SUBJECT: SEAT LIMIT STOPS

AFFECTED: M20J S/N 24-0361 thru 24-0387,
24-0389 thru 24-0394,
24-0396 thru 24-0403,
24-0405 thru 24-0412,
24-0414, 24-0416,
24-0418 thru 24-0422,
24-0424, 24-0425,
24-0427 thru 24-0430,
24-0432, 24-0434,
24-0435, 24-0433

FIGURE 20-211-1

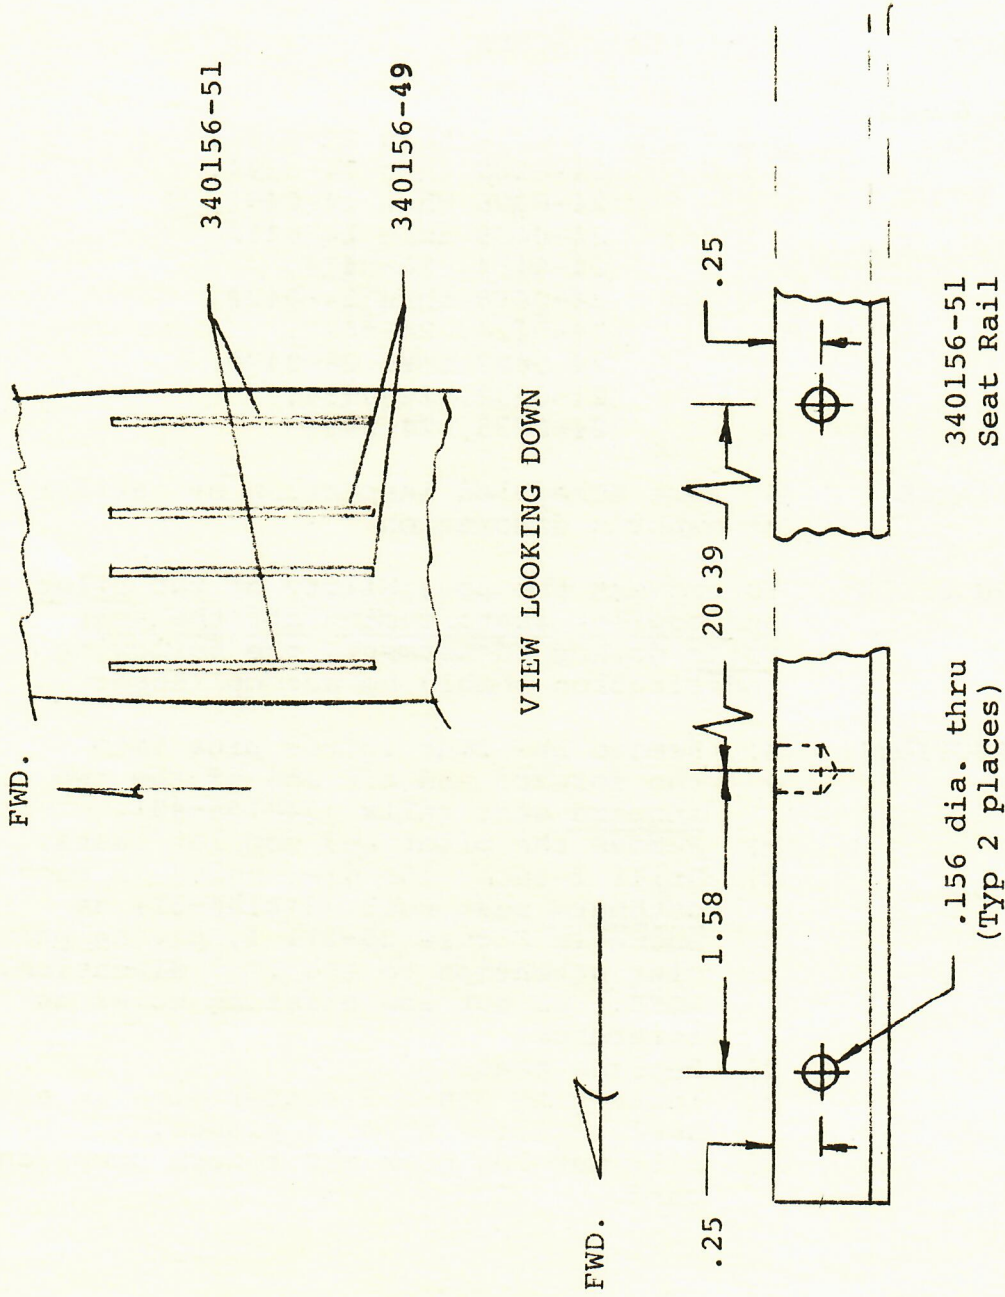
INTRODUCTION: To prevent the possibility of the pilot
and copilot seats coming off the seat
rails during adjustment, the following
modification should be accomplished:

- a) Remove the four cotter pins from the forward and aft end of the two inboard seat rails (340156-49).
- b) Remove the pilot and copilot seats.
- c) Drill 2 each .156 dia. holes in each outboard seat rail (340156-51) as shown in Figure 20-211-1, paying particular attention to the .25" dimension.
NOTE: Do not use existing holes as reference.
- d) Replace seats.
- e) Install AN 380-5-3 cotter pins in each newly drilled hole, 4 places.
- f) Fill out log book and return compliance card.
